**PERMIT
APPLICATION
REVIEW**

**RE: Request for Additional Information – Permit Application Review for a Proposed Centralized Surface Waste Management Facility
Black Hills Gas Resources - East Blanco Produced Water Reuse Facility
Location: SE/4 NW/4 of Section 13, Township 30 North, Range 4 West, NMPM
Rio Arriba County, New Mexico**

Request for Additional Information
Black Hills Gas Resources - East Blanco Produced Water Reuse Facility
Centralized Surface Waste Management Facility
September 10, 2012

SHEET
 P-2

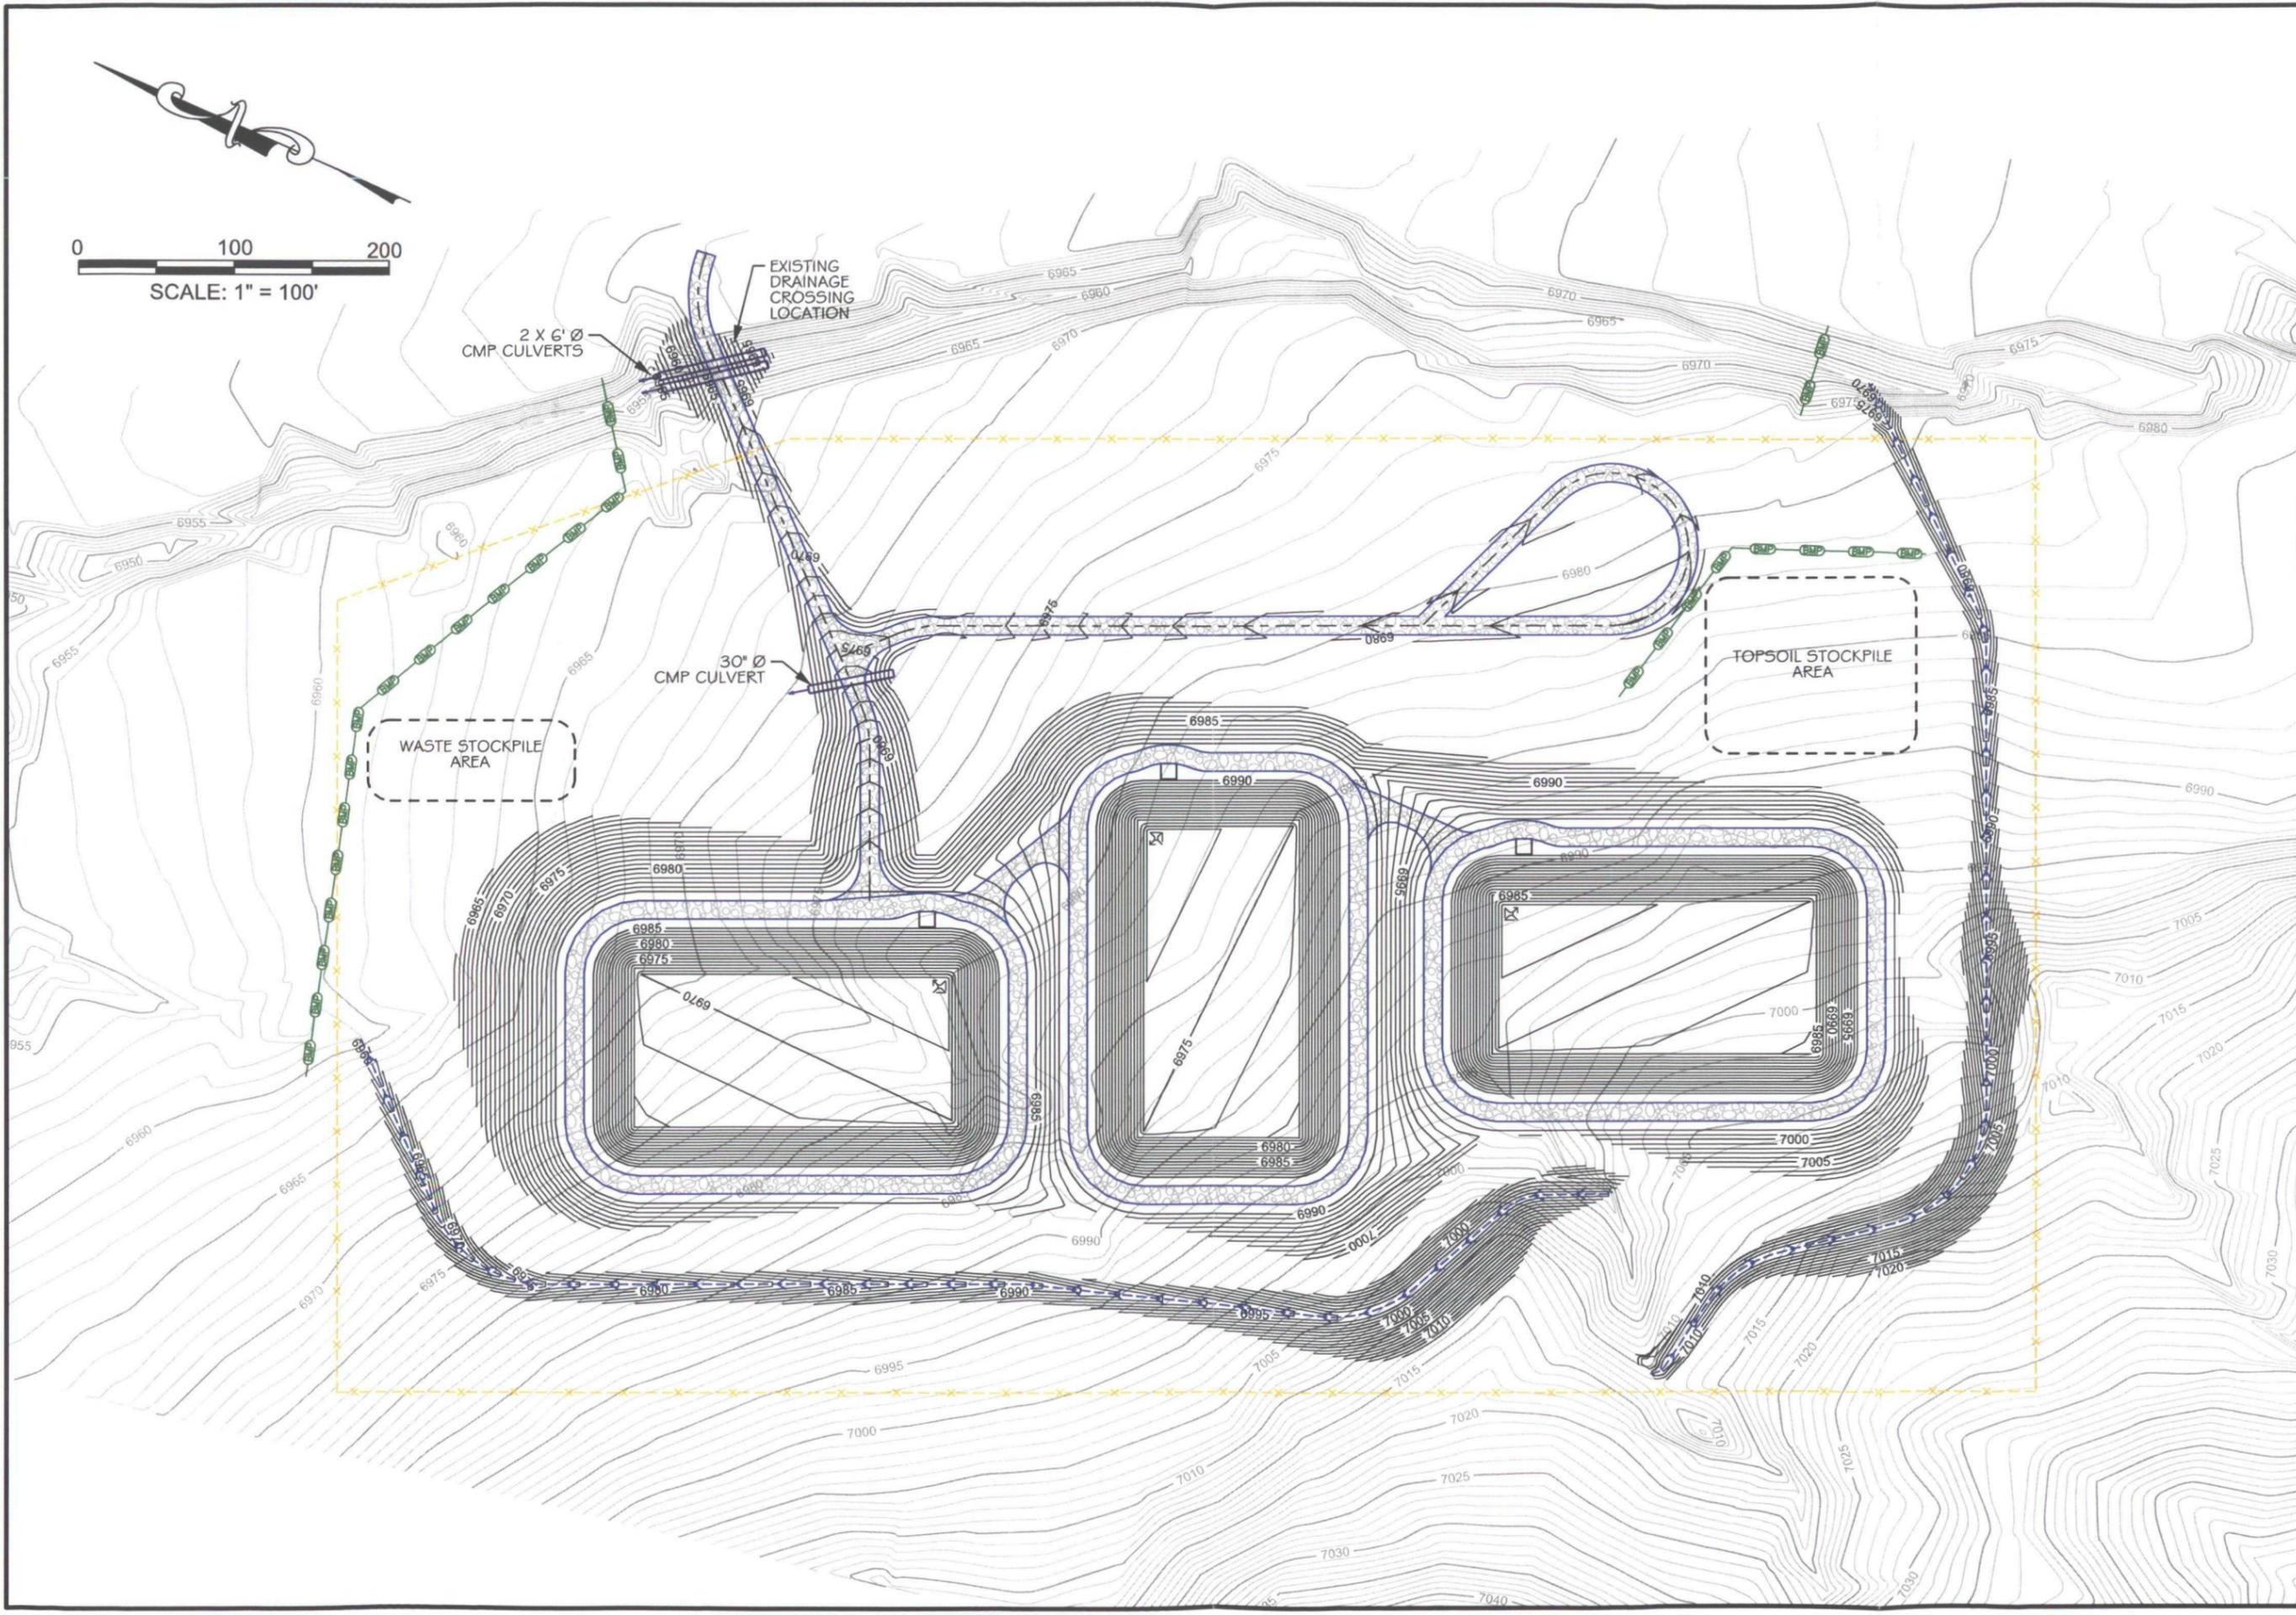
Sheet P-1, Location Overview; and Sheet P-2, Facility Layout:

The proposed pond designs and facility layout, Sheet P-2 of Appendix A, illustrate that the ponds will be constructed primary above the existing contours (steep slopes) above a watercourse, as defined by Paragraph (4) of 19.15.2.7.W NMAC. A surface release of produced water from one of the ponds would most likely result in the water flowing downhill toward the watercourse. The proposed “actions” should address and consider the site specific conditions of the proposed facility. Please provide the required information for each type of scenario and the detailed instruction to assist facility personnel with due consideration of the site specific conditions and surrounding topographical features of the proposed facility location.

The first sentence of the response states “Topsoil and fill stockpiles will be located away from drainages to prevent storm water contamination during construction.” Sheet P-2 of Appendix A illustrates that the proposed topsoil stockpile area will be located on a slope approximately 100 feet from

EAST BLANCO PRODUCED
WATER REUSE FACILITY
Pipe System Details

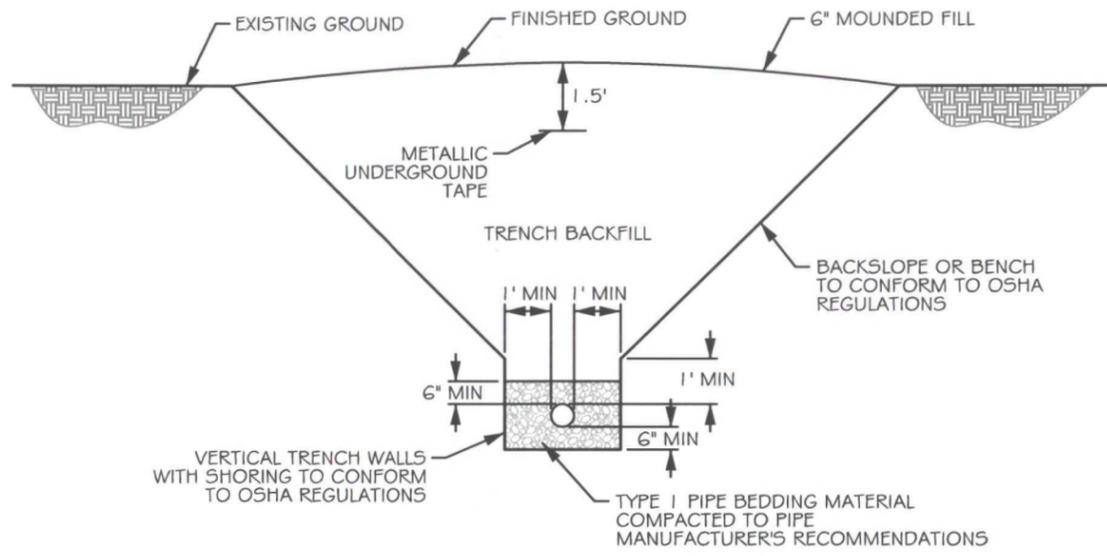
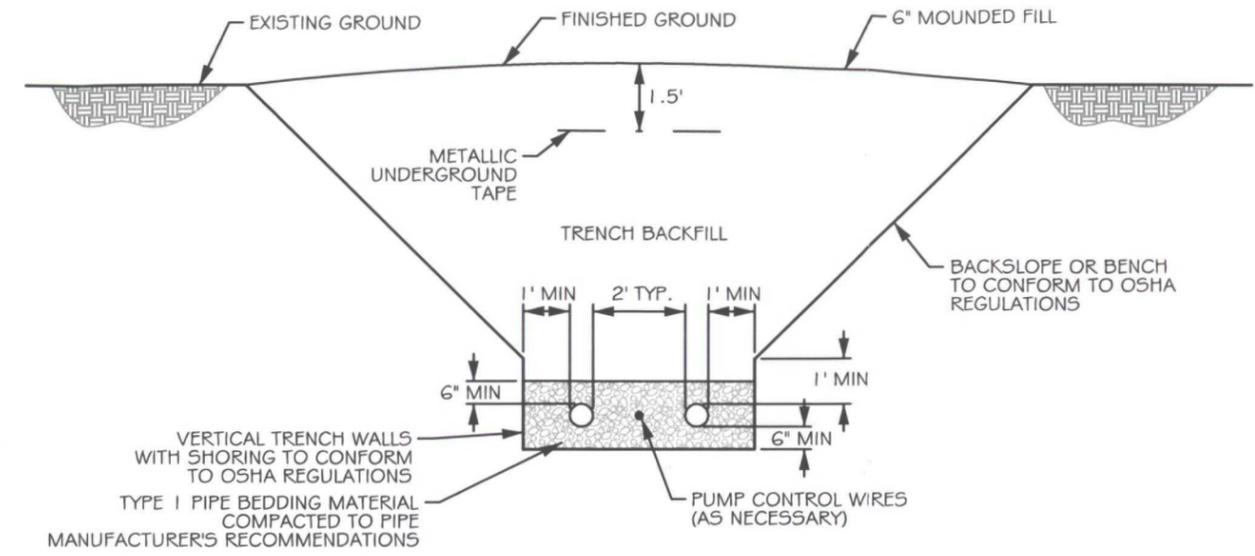
Sheet D-1, Pipe System Detail, Detail O/D-1:

The detection riser pipe is identified as having a "water level monitor." The note on the design drawing is the first and only mention of the "water level monitor." The water level monitor is part of the proposed design of the leak detection system. Please provide the details regarding what it is and how it operates.

SUMP DETAIL (5)
SCALE: 1" = 4' (D-1)

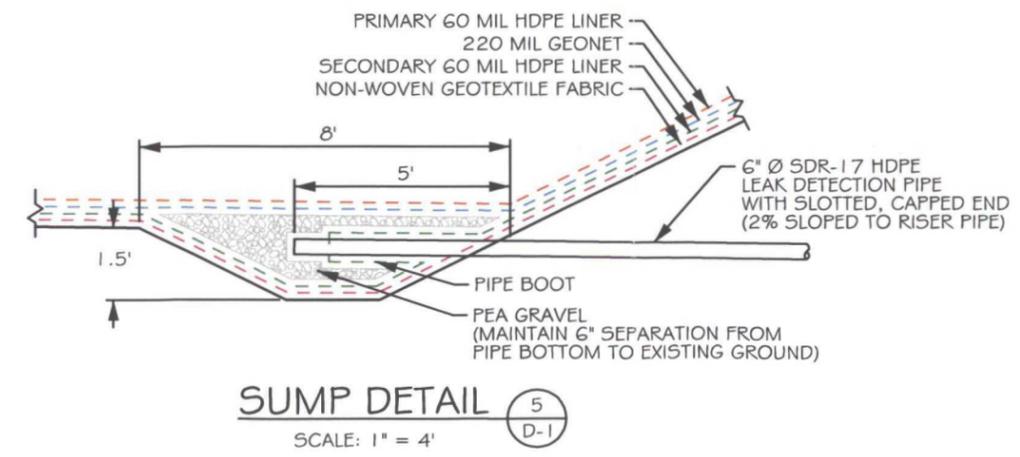
Sheet D-2, Pipe Trench & Liner Details, Sump Detail 5/D-1; Page 2 of 6, Section 02203, Part 2 and Part 3, Subpart 3.02:

This detail indicates that the leak detection pipe (the portion within the sump and the portion that extends outside of the secondary liner to the riser pipe) will be "slotted." The arrow points to the exterior pipe with this description and not the pipe within the leak detection sump. Please modify the drawing to identify the type of pipe proposed within the leak detection sump and the type of pipe proposed for use outside the lined pond. Also, pursuant to Paragraph (9) of 19.15.36.17.B NMAC, "The piping collection system shall be comprised of solid and perforated pipe having a minimum diameter of four inches and a *minimum wall thickness of schedule 80.*" This design specification is not recognized in any of the proposed design drawing. Please modify the design drawings appropriately to identify and include the required regulatory design specifications.

**FIGURE
1**

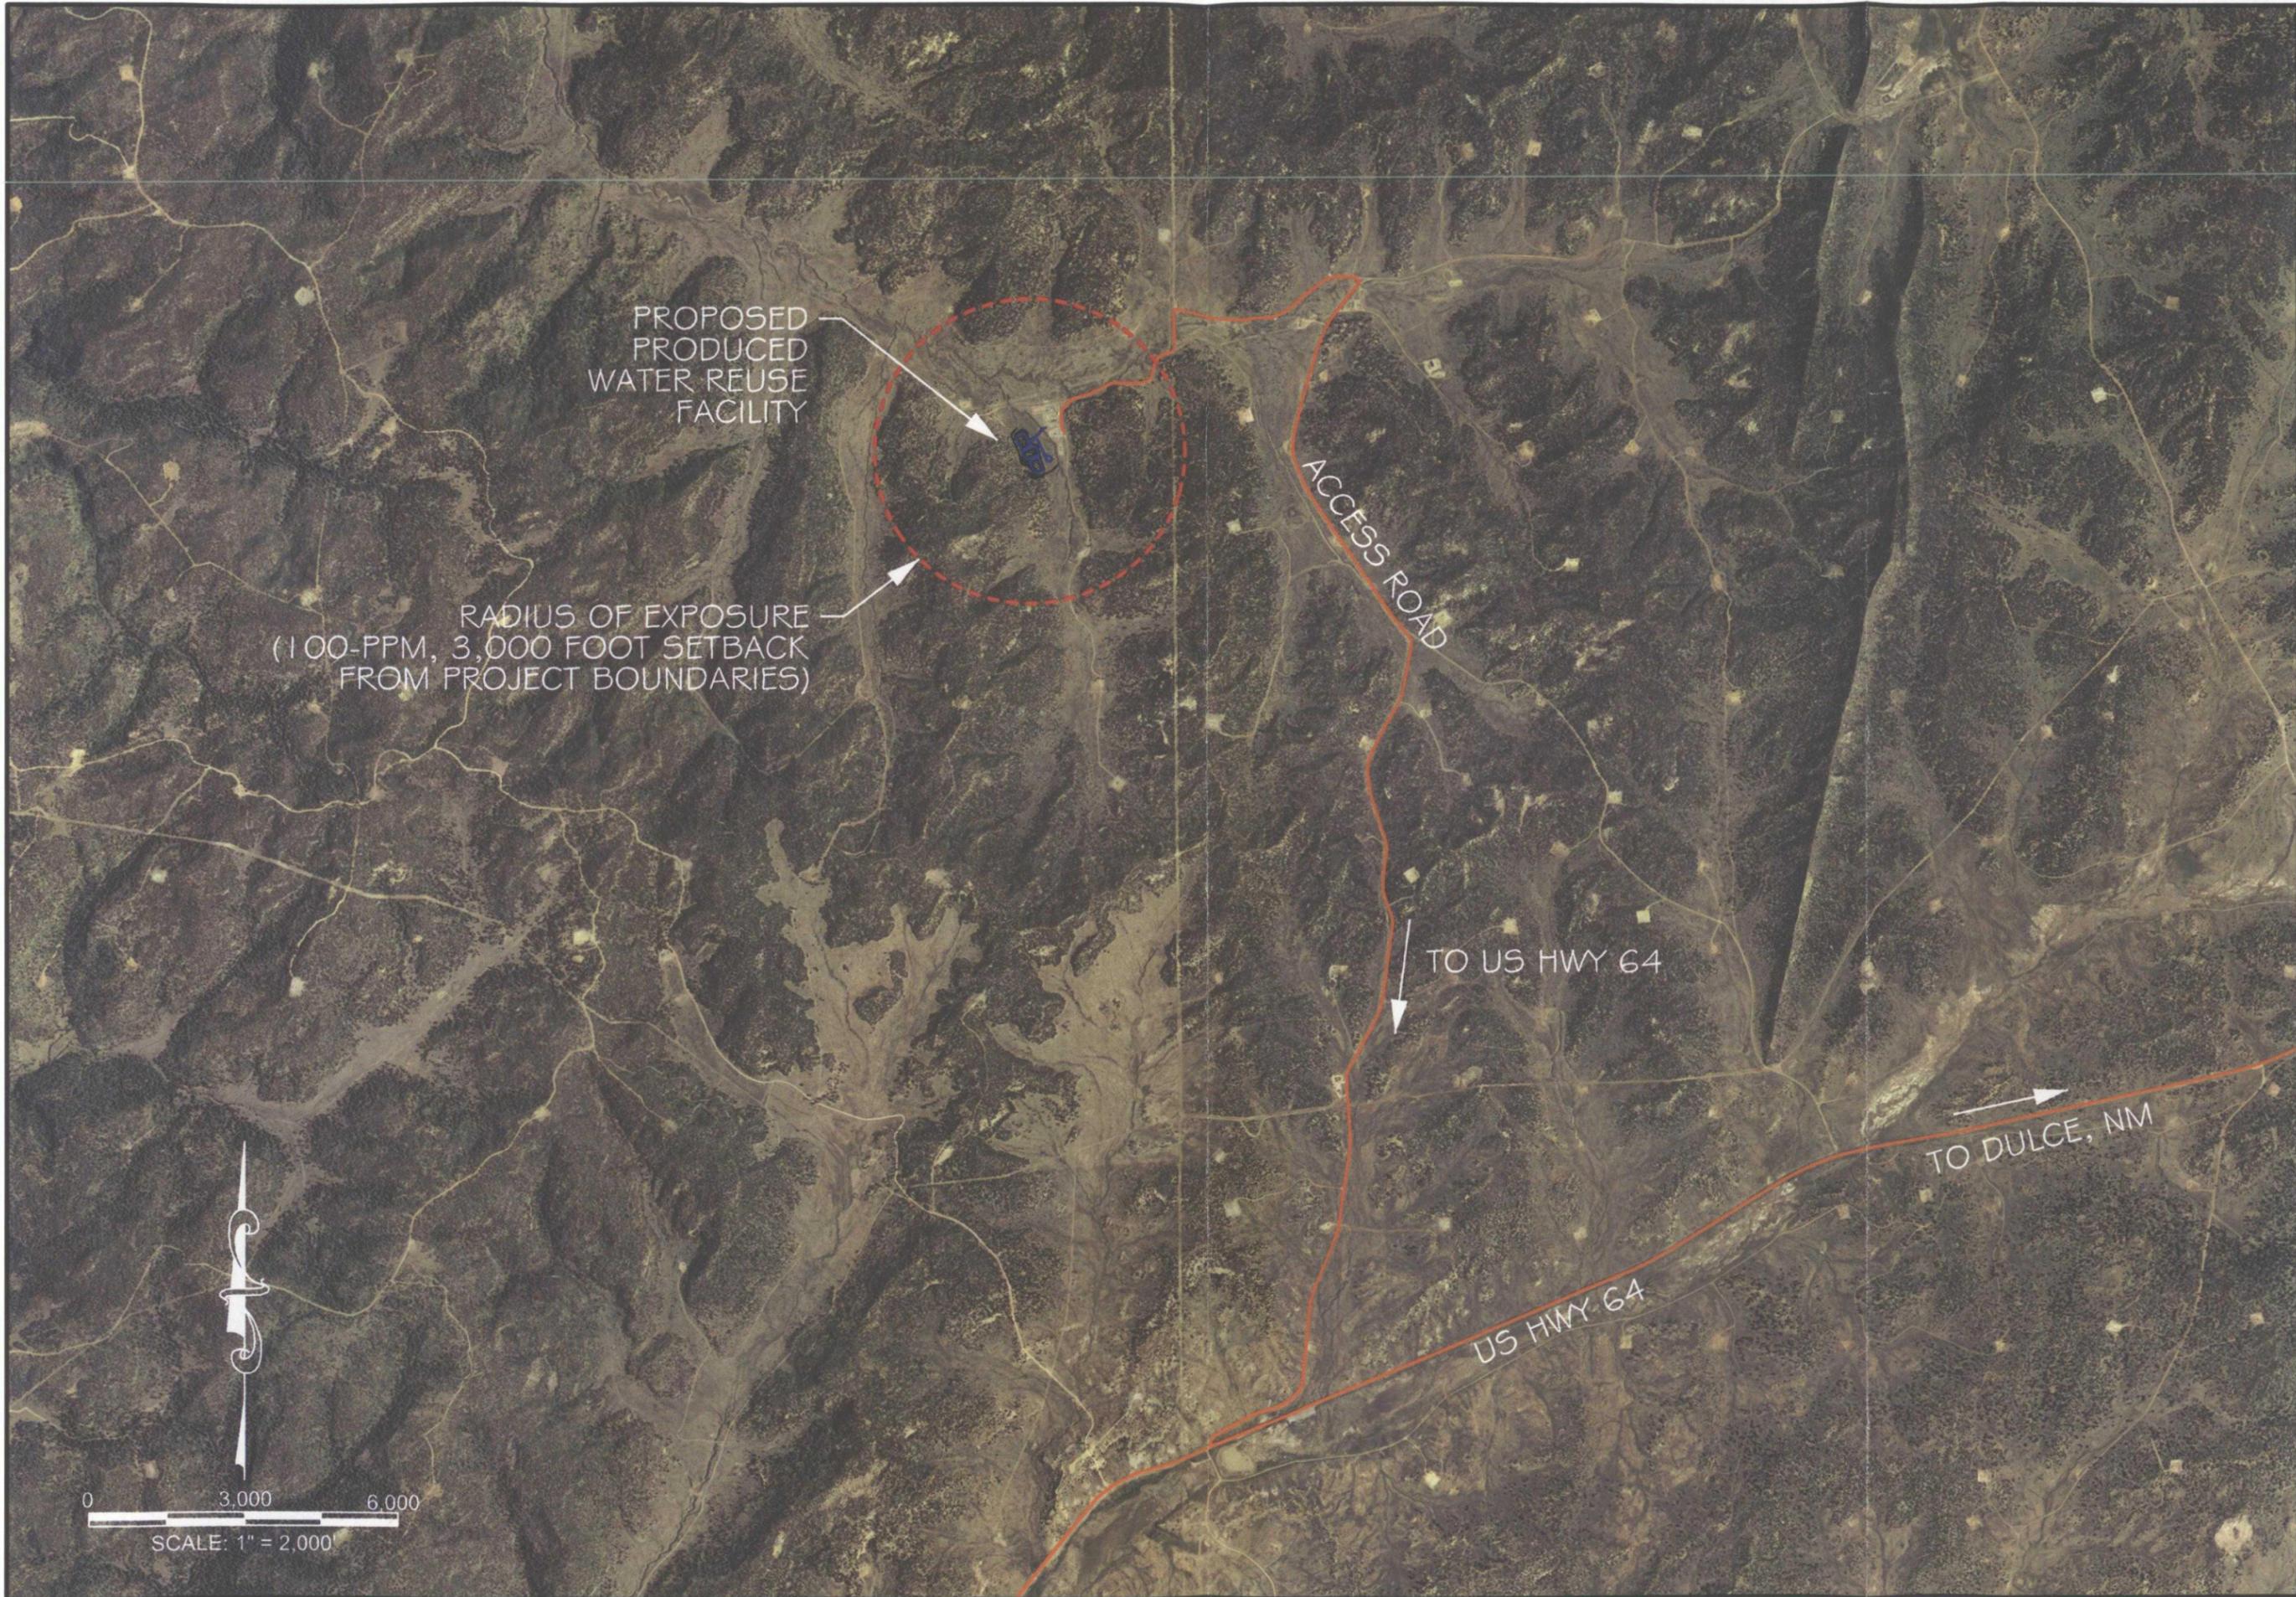
The proposed evacuation routes on Figures 1 and 2 illustrate the access roads back to US Highway 64. The hydrogen sulfide contingency plan does not propose evacuation routes or assembly points within and outside of the proposed facility perimeter. Please modify the plan to include facility evacuation routes and assembly points within and outside of the proposed facility perimeter.

The maps illustrate the access road to US Highway 64 as the only proposed evacuation route. There is not a facility layout map that proposes evacuation routes within the proposed facility to the facility boundary or established assembly points/areas to account for personnel and/or visitors. Please provide. Figures 1 and 2 are satellite or aerial images which seem to use the center of the middle impoundment as the basis of the 3000-foot assessment. Please establish a site perimeter (facility boundary) to properly demonstrate the 3000-foot assessment. Also, update maps to include proposed road blocks.

BOREHOLE: B-2
 BOREHOLE DEPTH: 55.0'
 GROUNDWATER DEPTH: NOT ENCOUNTERED
 GROUNDWATER ELEVATION: NOT ENCOUNTERED

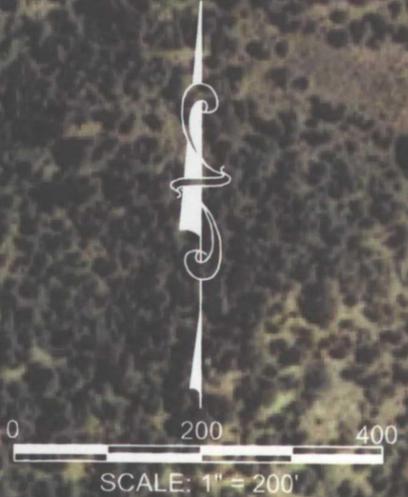
Figures, Figure 1, Hydrogeologic Investigation, Borehole Locations:

As identified by the title of Figure 1, the satellite or aerial image provides a detailed overlay of the proposed layout of the facility and identifies the boreholes, the borehole depth, ground water depth, and ground water elevation. The reason this figure is discussed is due to Borehole B-1 is consistently referred to as Borehole B-3 throughout the permit. As illustrated on Figure 1, ground water was encountered in B-1 and B-4. Borehole B-3 is located on the east side of the ephemeral drainage/watercourse and the note on the figure indicates that ground water was “not encountered.” Please perform a universal search for “B-3” throughout the permit application (including tables) and verify if the discussion is appropriate or if it is referring to the ground water encountered in Borehole B-1. Please make the appropriate modifications.
